IOWA ELECTRIC LIGHT AND POWER COMPANY

August 30, 1977
IE-77-1624

Your letter of June 2, 1977, concerning on-site emergency power systems requested information as it pertains to the Duane Arnold Energy Center. This transmittal includes responses to your June 2, 1977, letter, and proposed technical specifications change RTS-95. The enclosed proposed modifications are scheduled to be installed during the 1978 refueling outage.

PROPOSED CHANGE RTS-95 TO DAEC TECHNICAL SPECIFICATIONS

FIGURE 1 - DAEC ESSENTIAL ELECTRICAL SYSTEM

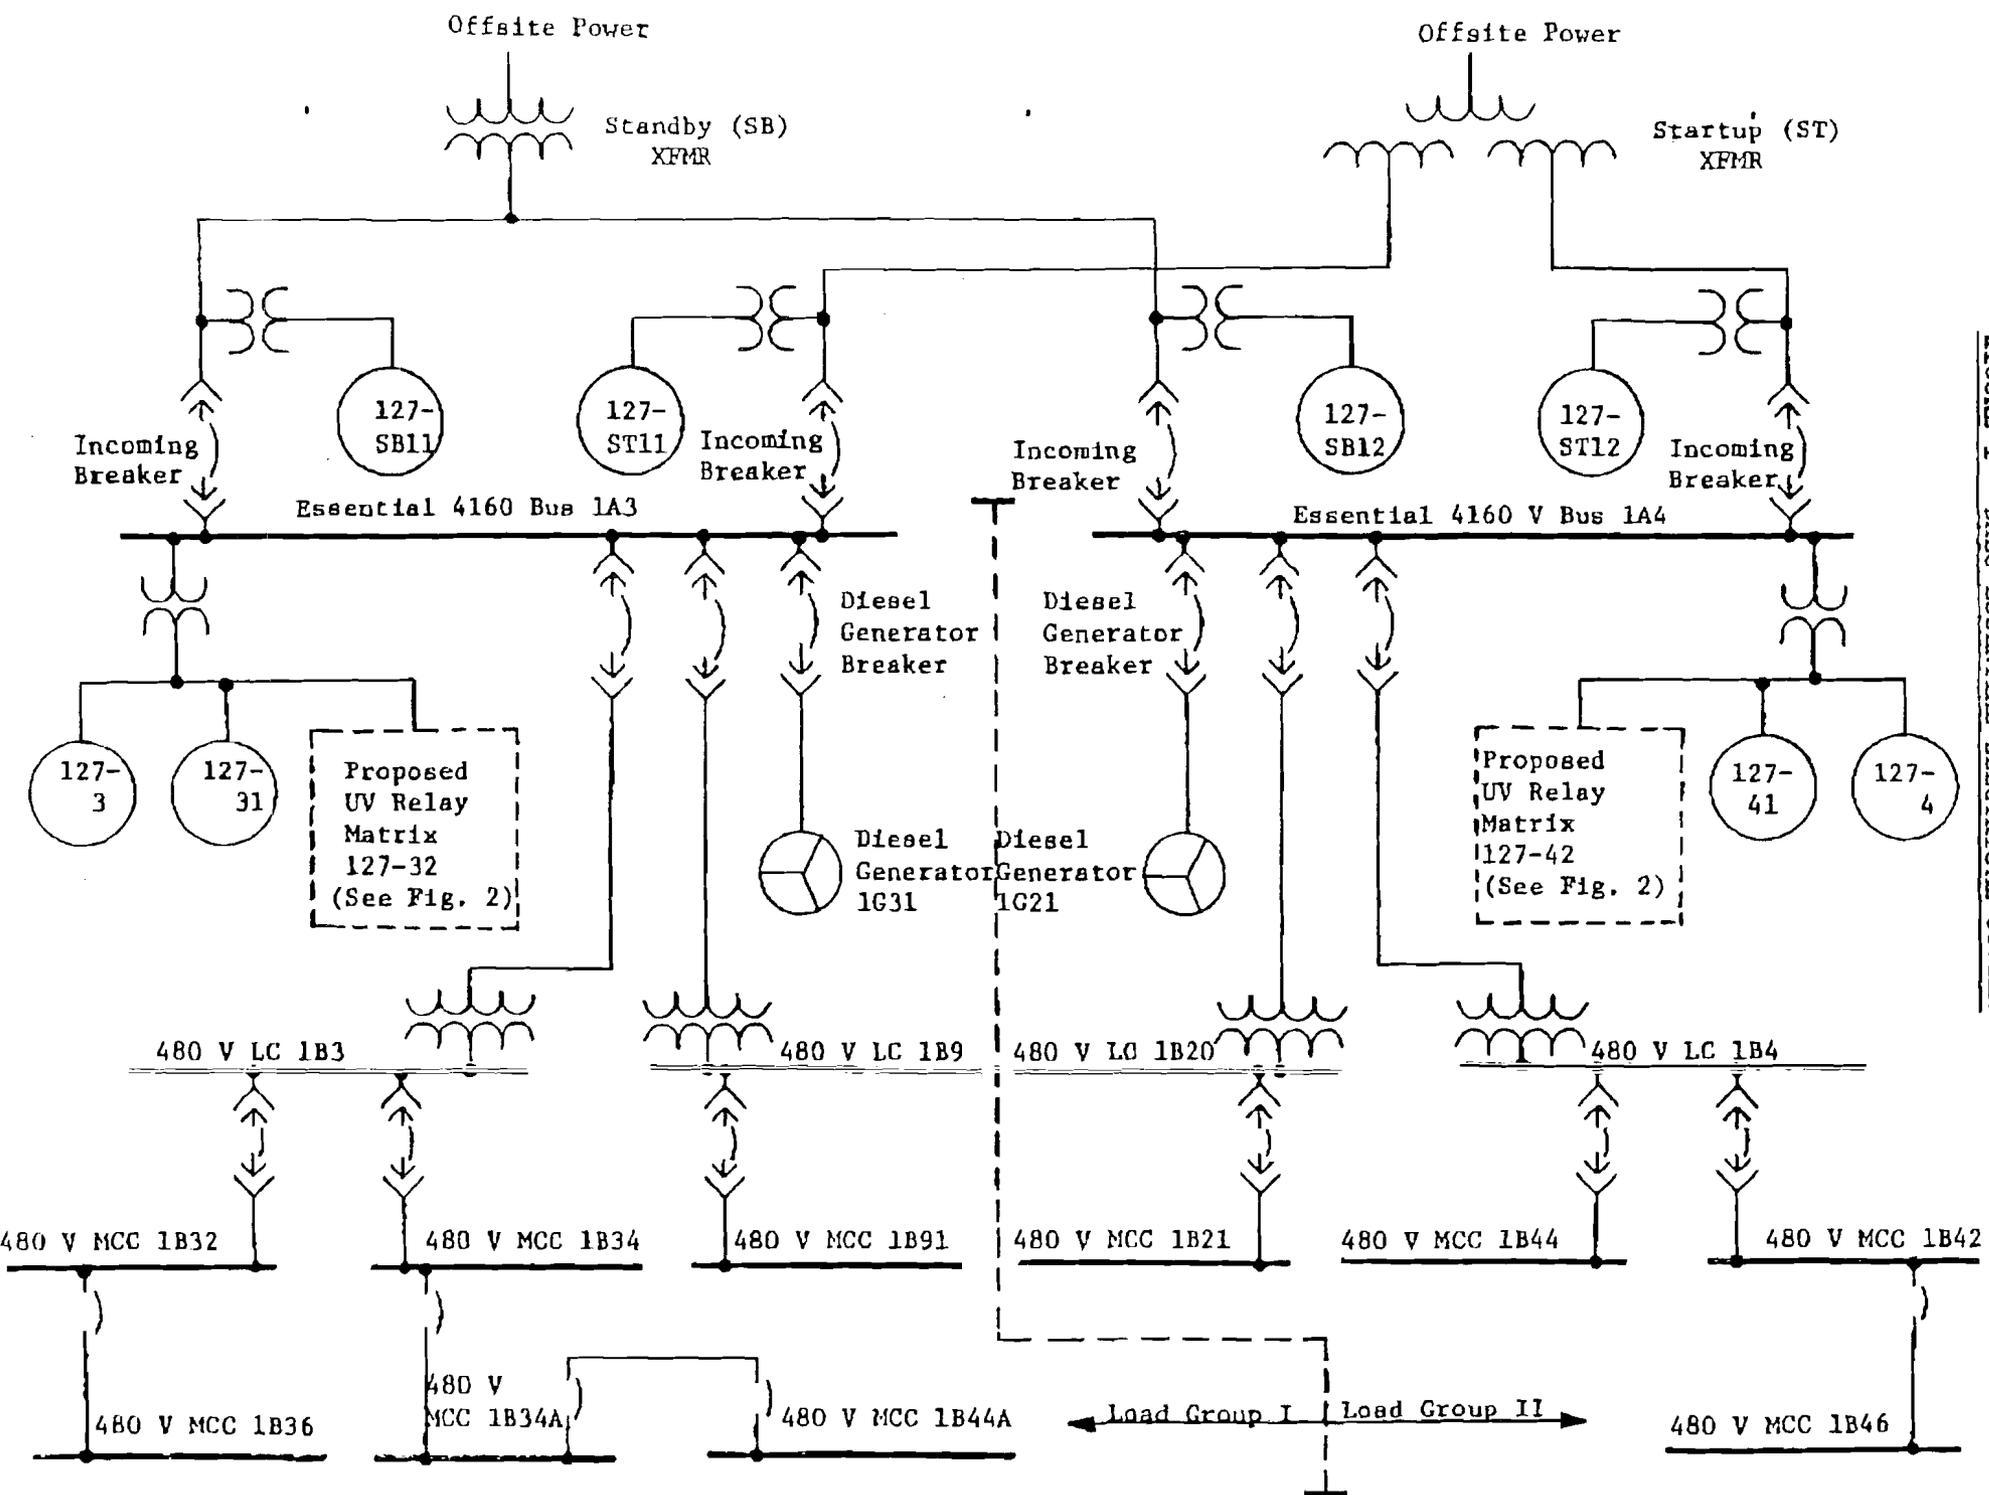
According to the voltage profile tables sent with our response of October 19, 1976 to your generic questions of August 11, 1976, essential motor control centers 1B36 and 1B46 consistently maintain the lowest voltage levels and may be considered the worst case. The voltage calculations made to prepare our previous response show that 86 percent of nominal voltage at MCC's 1B36 and 1B46 corresponds to a voltage level of 92.2 percent at 4.16 kV essential buses 1A3 and 1A4. We propose to establish the second level of undervoltage protection at 92.2 percent of nominal voltage on buses 1A3 and 1A4 by installing four additional single phase undervoltage relays to each of the essential 4.16 kV buses. Refer to Figure 1.

FIGURE 2 - UNDERVOLTAGE RELAY COINCIDENCE LOGIC

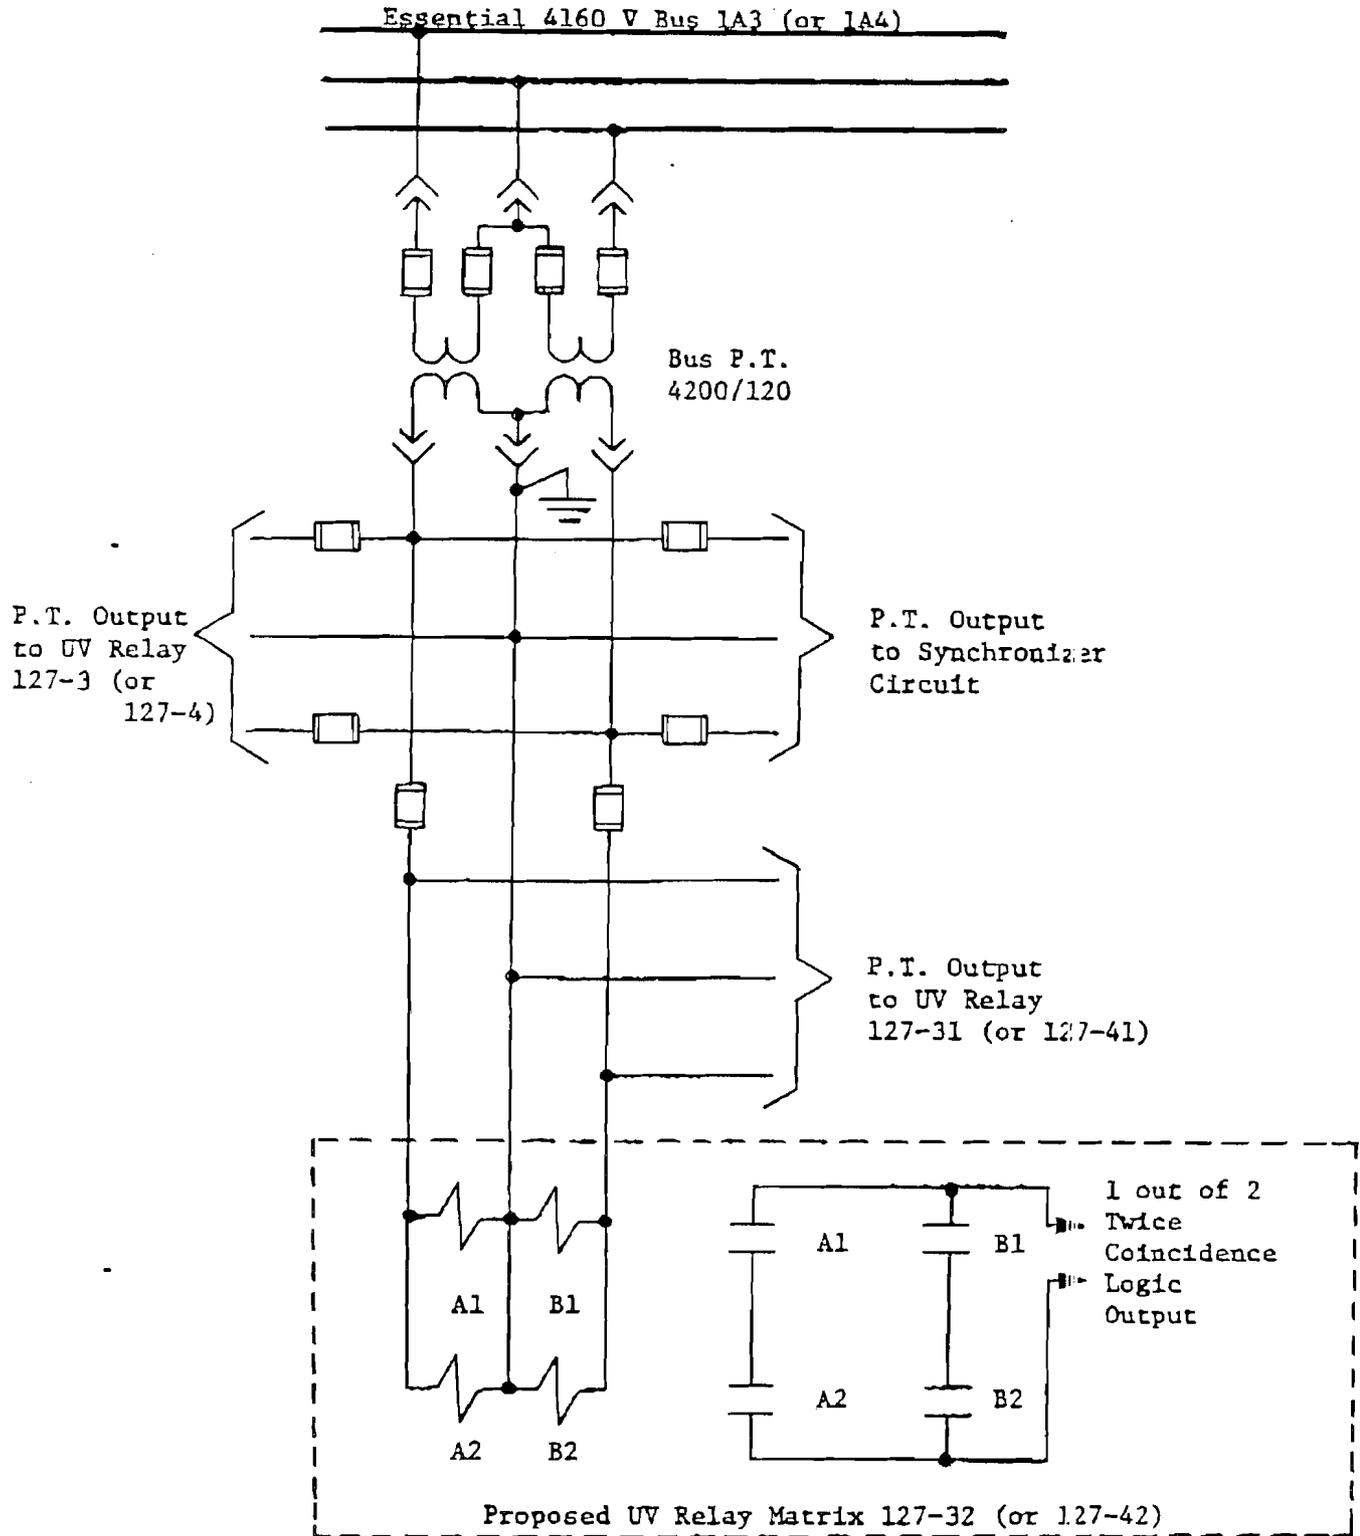
The output contacts of the four undervoltage relays on each bus will be connected in series parallel to form a one-out-of-two-twice coincidence logic matrix. Refer to Figure 2. The one-out-of-two-twice coincidence logic is already used in the Reactor Protection System. The coincidence logic precludes a single blown Potential Transformer (P.T.) fuse or malfunctioning relay from either preventing a safety action when it is required or causing a spurious trip of an offsite power source. The coincidence logic permits relay testing and calibration during power operation. The coincidence logic is fail safe.

The proposed logic is designed to meet IEEE Std. 279-1971, "Criteria for Protection Systems for Nuclear Power Generating Stations." The logic for each bus is completely independent and separated from the logic for the other bus. Coincidence logic is used so that no single blown P.T. fuse or malfunctioning relay will prevent a safety action when it is required. All of the equipment is seismically qualified. The logic is capable of being tested and calibrated during power operation.

1. The proposed relays are instantaneous undervoltage relays with integral timers. The relay output contacts open if the monitored voltage drops below the voltage setpoint for the length of the time delay. The logic is fail safe.
2. The bus and relay numbers listed first are for Load Group I. The numbers in parentheses are for Load Group II.
